ELECTRICAL SAFETY INSPECTION REPORT

KNIT BAZAR (PVT.) LTD.

Inspected on April 5, 2014

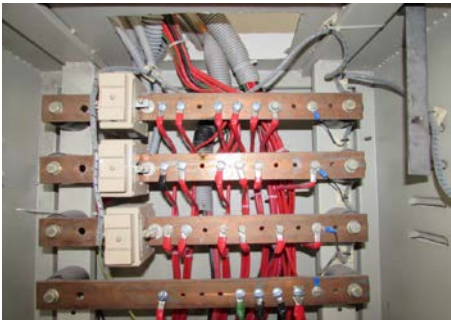
Finding #: E- 5	 Cables connected to bus bar
Category: SWITCH BOARD & PANELS	
Finding: Incoming cable in the panel directly connected to bus bar.	
Recommendation: Cables shall be connected to terminals only by soldered/welded lugs according to the size of the respective cables. Proper crimping tools must be used to punch the socket.	
Remediation Timeframe: Within 1 month
